Government of India
Ministry of Railways
Research Designs & Standards Organisation
Manak Nagar , Lucknow - 226011

No. EL/3.2.92/3

MODIFICATION SHEET NO. RDSO/WAM4/177

Rewinding of MCP "Siemens Make" of 10.5 KW/14 HP, TEFC with dual coat wire or double glass covered copper enamelled conductor type ILA6 188-6YA90-Z.

REWINDING DIAGRAM FOR SIEMENS
MAKE MCP TYPE ILA6 186-6, ILA6-188-6

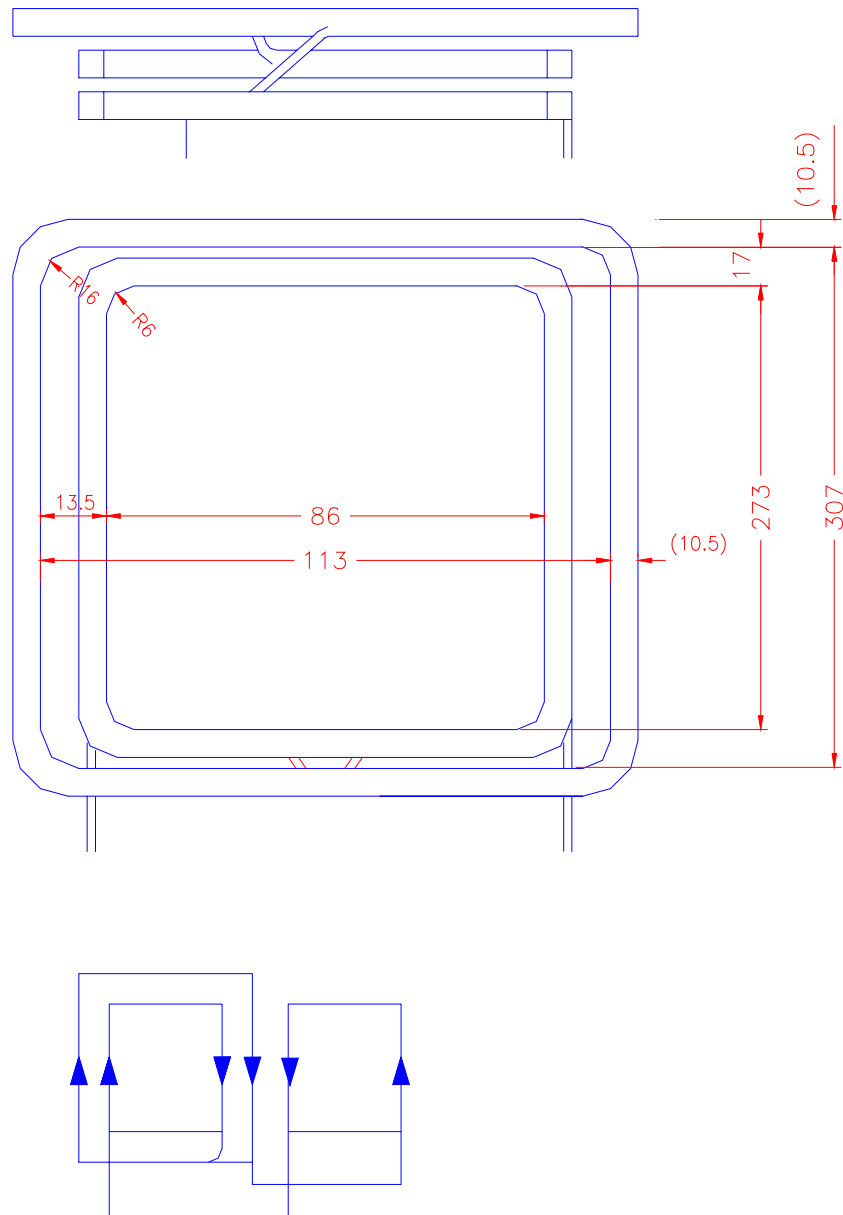
3.3 Further for rewinding of the 10.5 kw, TEFC, MCPs supplied by Siemens (Dual coat or DGCC), the rewinding scheme is enclosed for adoption. This should be incorporated on all 10.5 kw TEFC MCPs of designs (iii) and (iv) in para 3.1 above.

3.4 Modified stator winding will be suitable from 290V-500V to take care of problem of low voltage reported by Railways.

1) Drawing No. SK. EL. - 4262 indicating developed winding diagram.
